DATED: 12-30-87
ISSUE # T- 7

SUBJECT: Jumper Wire Guide

MODEL: 2700

REF.:Page II-30 in
your parts book

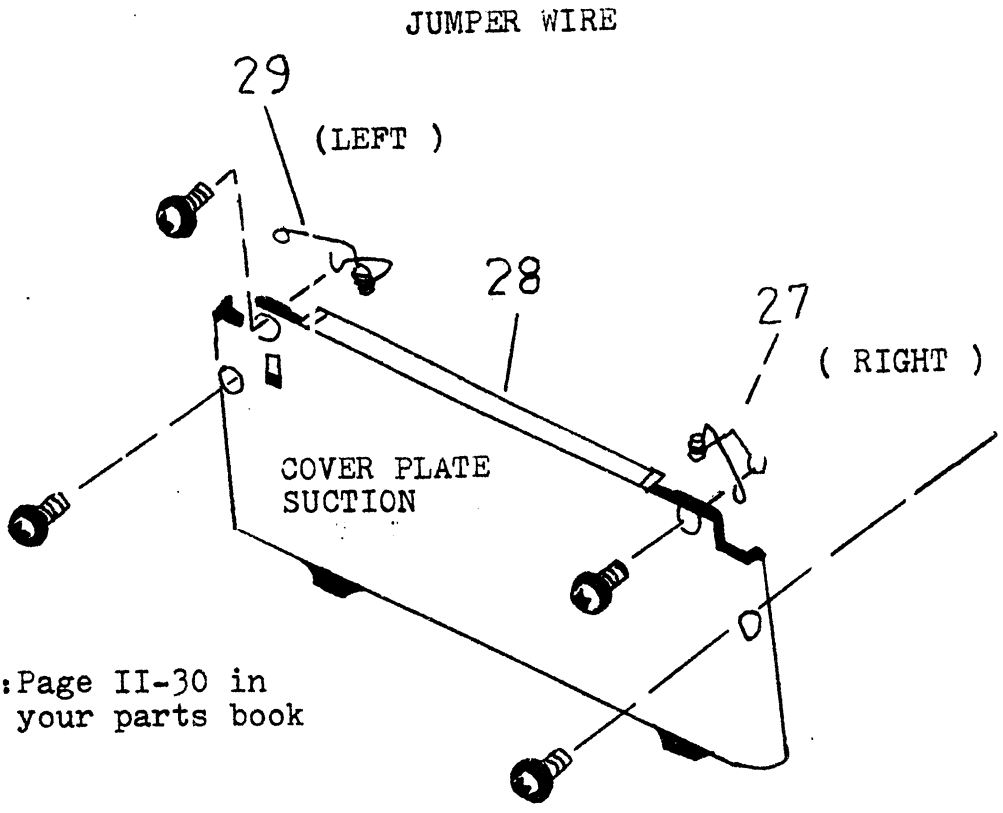
Jumper wire (left) part # 002-13247-000 and (right) part # 002-13246-003 has been added to the suction unit to aid paper sizes larger that letter size during transport to receiving tray. Machines manufactured from serial number 90410091 have jumper wires, previous machine numbers can be updated as needed.
